REMARKS

T. Hiramatsu
U.S.S.N. 09/674,068
Page 30

FIG. 7 PRIOR ART

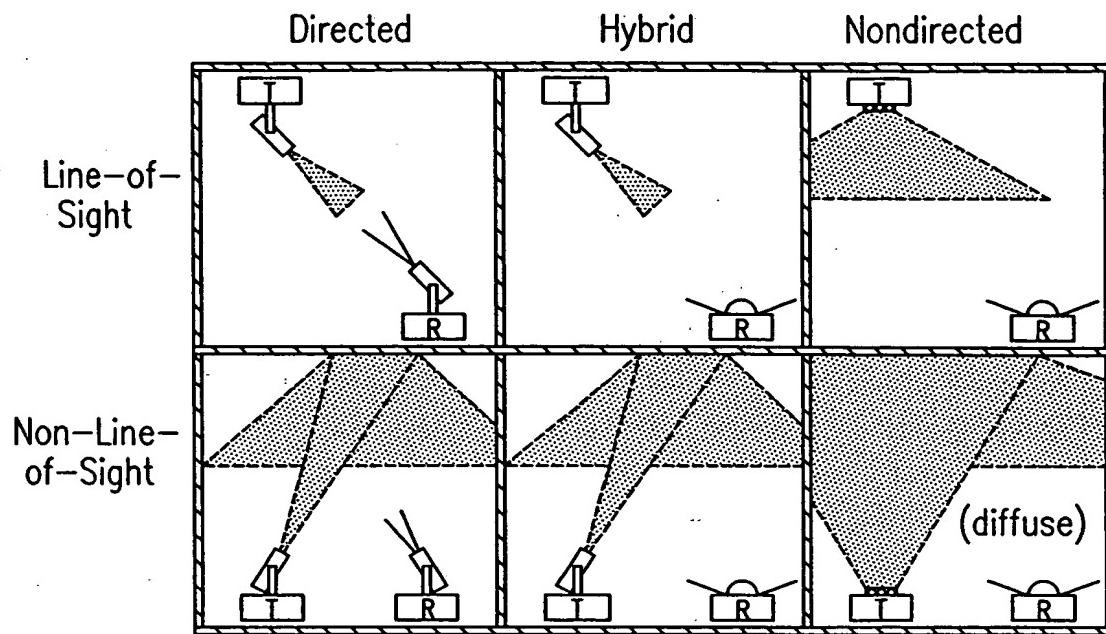
2. Objected to the Drawings on the grounds that Figures 7 and 8 should be designated by a legend such as -- PRIOR ART -- since only that which is admitted to be old is shown therein – **Applicant herewith has included a Request for Drawing Change Approval including the attached photocopies of Figures 7 and 8 showing the proposed changes in red which adopts the Examiner's suggestion for the addition of the legend -- PRIOR ART -- to Figures 7 and 8, and concurrently herewith has submitted a new set of formal drawings incorporating those changes – acceptance of Applicant's proposed drawing changes and the entry of the new set of formal drawings submitted concurrently herewith is respectfully requested in response to this communication;**

FIG. 8 PRIOR ART

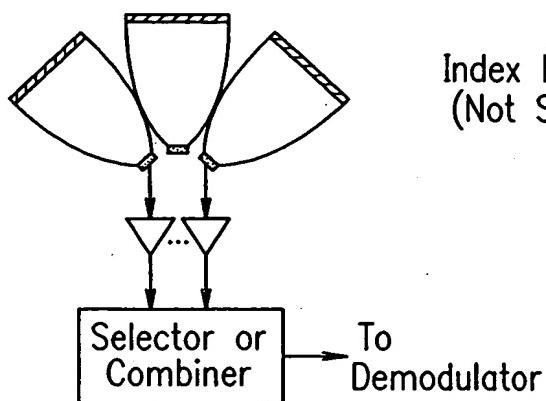
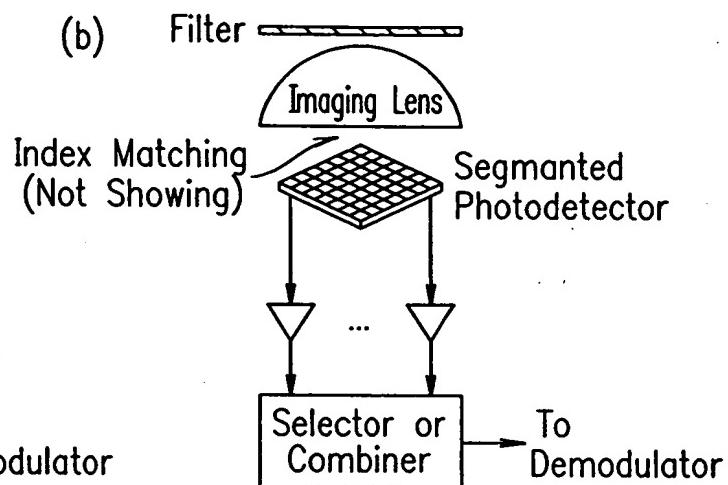
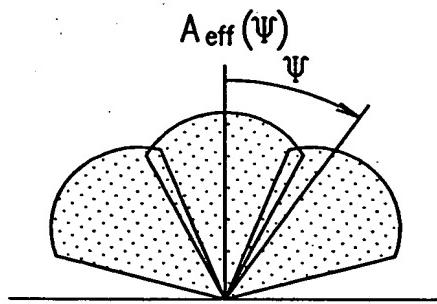
The relationship referred to by the Examiner can be readily understood by comparing a pair of (a) and (c) and a pair of (b) and (d) in Fig. 8 of the present application. Thus, assume that both structures (a) and (b) of Fig. 8 perform three space-division multiplexing operations in a certain angle direction, similar to that shown in (c) of Fig. 8. In such a case, in the structure of the angle-diversity type receiver of (b) of Fig. 8, there are three detector outputs for each angle range divided into three, i.e., nine detector outputs in total. Thus, the spatial resolution of each of the detectors is three times that of the divided space cells. By selecting the one having a maximum SNR out of the three detector outputs corresponding to one space cell, or combining the outputs to generate one output, an output that is independently operable can be obtained for each of the three space cells.

On the other hand, in the structure of the angle diversity type receiver of (a) of Fig. 8, there is one detector output for each of the three divided angle ranges, and the scope of the resolutions of the respective detectors are equal to those of the divided space cells (of course, if the total number of the space channels is small, even this structure can be used as a space-division multiplexing system by retrieving three independent outputs for three space cells). At the same time, the structure corresponds to that shown on the right hand side of Fig. 22 of Ota. However, in the case of Ota, space diversity is performed by selecting one having the maximum SNR out of three outputs obtained for the entire space, or combining them to generate only one output. The structure shown in Fig. 14 of Welch also corresponds to the latter structure. As described at Col. 13, lines 53-55 of Welch, a single output can be obtained from a set of a plurality of detectors having the same optical axis that are arranged in parallel as an array. However, as described at Col. 8, lines 31-38 of Welch, it merely forms a single omnidirectional space channel as a transmitter/receiver the same as disclosed by Ota.
